2.0 DESCRIPTION

2.4 CPW Roof Top Enclosure

Figure 14 APPROVED PLAN
Approved plan zoomed in from Drawing: 552-19413-CPA PL2 (Not to Scale)

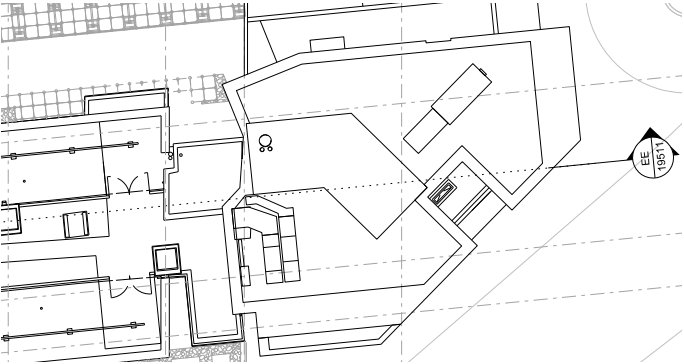
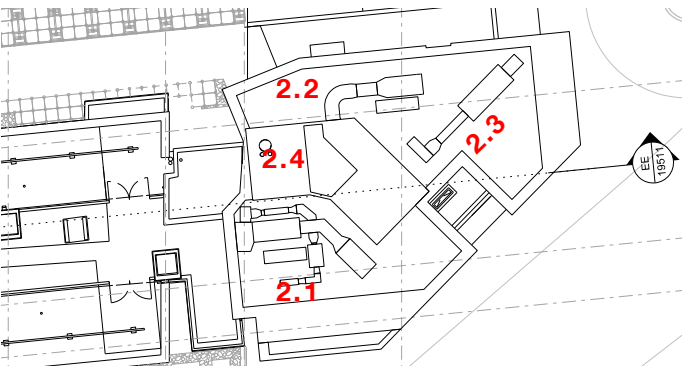
A small portion of the rooftop enclosure roof is proposed to be omitted to facilitate access beneath to what is otherwise a 1.4m high enclosure. This void space avoids safe access from beneath through a hatch but also safe access across east-west through flush louvre doors. The rooftop enclosure is not proposed to be extended or altered in any other way.
